Memo To: Diya Matroja, Planner I – Development
From: James Pavlidis, Urban Designer

Subject: Zoning By-Law Amendment

Applicant Name: KLM Planning Partners Inc.
Municipal Address: 11198 Bayview Avenue
Legal Description: Plan 4007 Lot 3
City File No.: ZBLA-24-0004

Appendix

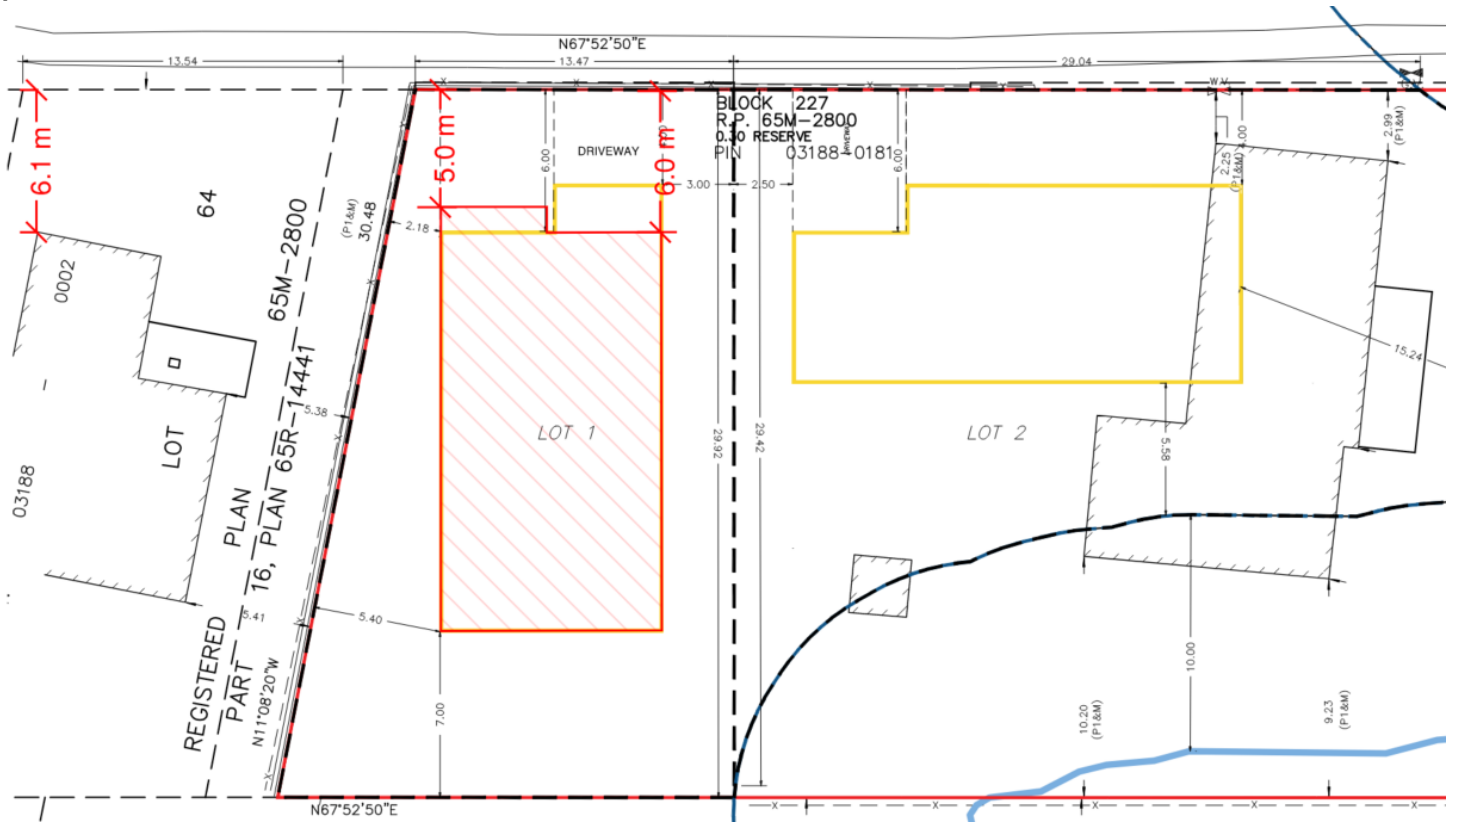
Average the front yard setback of Lot 1, to respect the existing streetscape character and maintain a well-defined street edge; pair driveways to maximize permeable area and opportunity for landscape planting.
